RE: **7901 Las Lomas NE**
Grading Plan Stamp Date: 9/28/19
Drainage File: D16D002I

RE: **7901 Las Lomas NE**
Grading Plan Stamp Date: 7/29/19
Drainage File: D16D002I

Based on the submittal received on 8/7/19, the grading plan cannot be approved until the following corrections are made:

ENGINEER'S SEAL	7901 LAS LOMAS	DRAWN BY WCWJ
	GRADING AND DRAINAGE PLAN	DATE 6-05-19
		2109049-LAYOUT-6-05-19
		SHEET # —
9/28/19		SHEET # —
DAVID SOULE P.E. #14522		1606 CENTRAL AVENUE SE SUITE 207 ALBUQUERQUE, NM 87106 (505) 872-0899

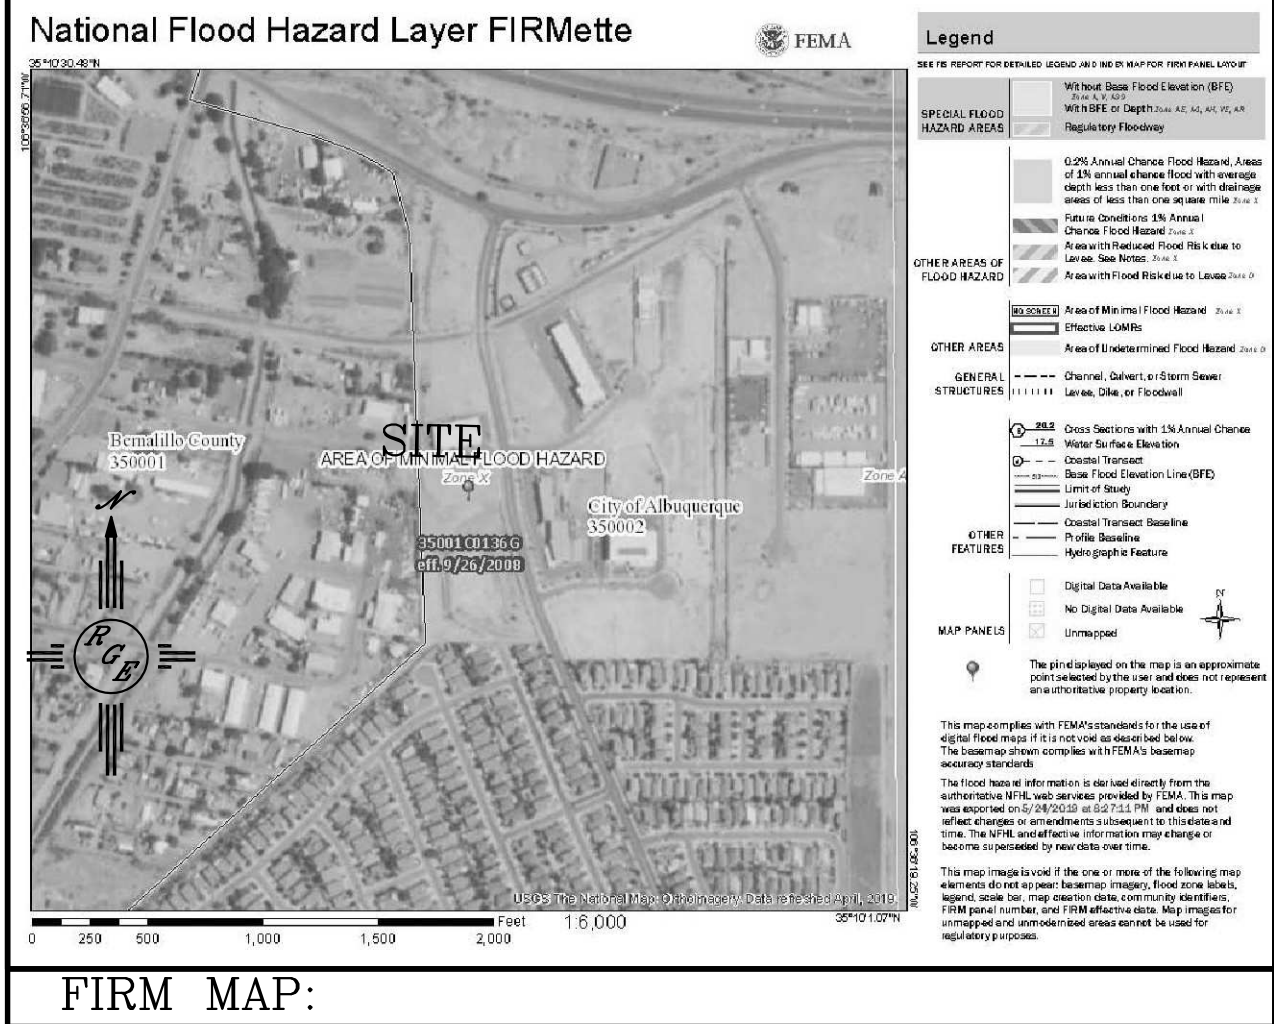
1. Show the public drainage easement for the storm drain. The inlet and private storm drain cannot encroach on the storm drain easement. **added**
2. Show the outlet structure into the pond for the private storm drain line with additional detail to be shown on the work order. **added**

3. Site Hydrology, Hydraulics, and Narrative are missing now. **added**
4. As a reminder, if the project total area of disturbance (including the staging area and any work within the adjacent Right-of-Way) is 1 acre or more, then an Erosion and Sediment Control (ESC) Plan and Owner's certified Notice of Intent (NOI) is required to be submitted to the Stormwater Quality Engineer (Curtis Cherne, PE, ccherne@cabq.gov, 924-3420) 14 days prior to any earth disturbance. **yes**

Based on the submittal received on 8/29/19, the grading plan is approved for Grading Permit and Building Permit.
